Rezoning Transportation Analysis

Petition Number: 2023-011

General Location Identifier: 04521224, 04521223

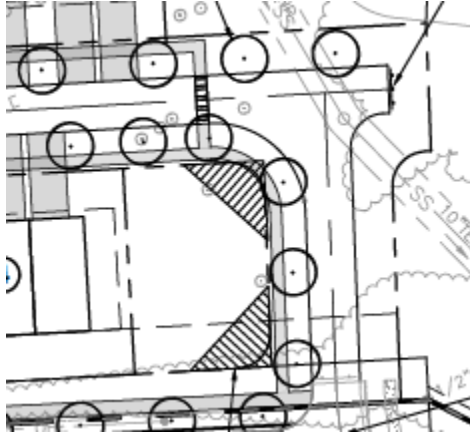
- ~~4. Revise site plan and conditional note(s) to commit to construct an 8-foot planting strip, and 6-foot sidewalk on all internal roadways Chapter 19. The site plan shall label and dimension both items from the back of curb and gutter or edge of pavement.~~

~~**Clarifying comment 6.21.2023:** Add conditional note to construct 8-foot planting strip and 6-foot sidewalk on all internal roadways.~~

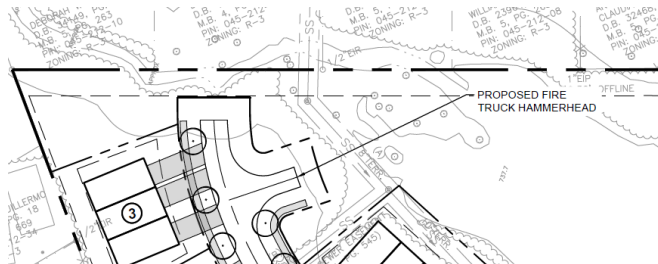
- ~~5. Add a conditional note specifying "A Right of Way Encroachment Agreement is required for the installation of any non standard item(s) (irrigation systems, decorative concrete pavement, brick pavers, etc.) within a proposed/existing City maintained street right of way by a private individual, group, business, or homeowner's/business association. An encroachment agreement must be approved by CDOT prior to construction/installation. Contact CDOT for additional information concerning cost, submittal, and liability insurance coverage requirements."~~
- ~~6. Revise site plan and conditional note(s) to commit to streetscape along both sides of all proposed roadways.~~
